**KNOXVILLE HISTORIC ZONING COMMISSION
STAFF REPORT - CERTIFICATE OF APPROPRIATENESS APPLICATION**

PROPERTY ADDRESS: 401 E Oklahoma Ave 37917

FILE NO.: 3-D-18-HZ

LEVEL OF WORK: Level II. Major repair or replacement of materials or architectural elements

401 Oklahoma - Proposed windows and siding on rear

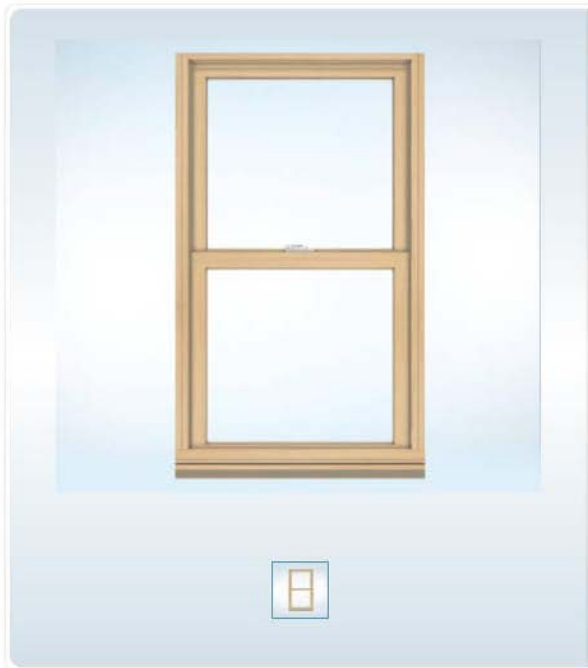
- 5) The hipped roof porch on the rear was enclosed at a late date and is not historically significant.
- 6) Replacing the metal storm-type windows with wood double-hung windows that are 6 inches taller, and adding a wooden beadboard wainscoting will create a more appropriate sunporch appearance. The 1/1 window style will not replicate the 2/2 original windows, with the difference signifying that the porch enclosure is a later modification to the house. The taller windows are more proportionately appropriate and the 1/1 lights are more typical of a sunporch.

Staff recommends approval with the conditions that 1) a section detail through the proposed wooden trim on the wainscot on the rear be provided to show the relationship of the trim to the beadboard below and the horizontal wood siding above; and 2) the size of the proposed casement window on the rear north side be provided.
